Project	IEEE 802.20 Working Group on Mobile Broadband Wireless Access < http://grouper.ieee.org/groups/802/20/ >	
Title	Draft Meeting Minutes, 802.20 Interim Meeting - Session #10, Berlin, Germany September 13-17, 2004	
Date Submitted	2004-9-17	
Source(s)	Rao Yallapragada QUALCOMM, Incorporated 5775 Morehouse Drive San Diego, CA, 92121	Voice: +1 858 658 4540 Fax: +1 858 651 2880 Email: rao@qualcomm.com
Re:	802.20 Session#10	
Abstract	Draft of the Minutes of the Session #10;	
Purpose	Minutes of the Session.	
Notice	This document has been prepared to assist the IEEE 802.20 Working Group. It is offered as a basis for discussion and is not binding on the contributing individual(s) or organization(s). The material in this document is subject to change in form and content after further study. The contributor(s) reserve(s) the right to add, amend or withdraw material contained herein.	
Release	The contributor grants a free, irrevocable license to the IEEE to incorporate material contained in this contribution, and any modifications thereof, in the creation of an IEEE Standards publication; to copyright in the IEEE's name any IEEE Standards publication even though it may include portions o

Figure 1 Link Simulation Model to include the effects of Adjacent Channel Interference

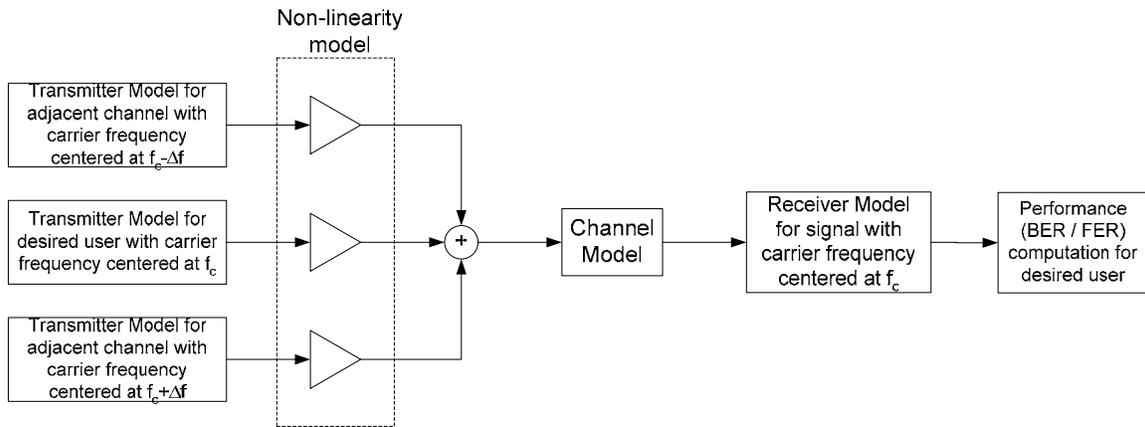
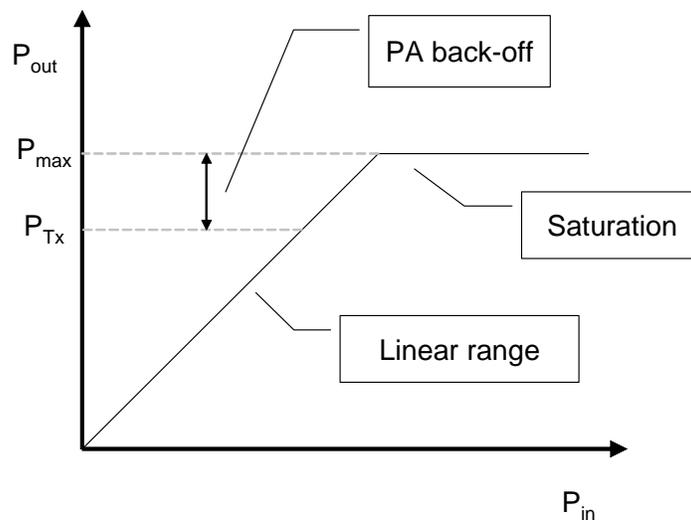
Option 1: To keep the following text in Section 3.3 but as unaccepted by the WG

When multiple frequency channels are deployed in an assigned channel block, the effect of adjacent channel interference can be modeled and included in the link level simulation as shown in Figure 1. A non-linearity model that can be used in the simulation is shown in Figure 2 [TBD]. Link performance of the desired user under the effect of ACI can be obtained through the computation of error probabilities at the receiver. The result of link performance should then be incorporated into the system level simulation.

Option 2: Delete the text and need a new text

Section 3.3 is deleted and a new proposal is invited.
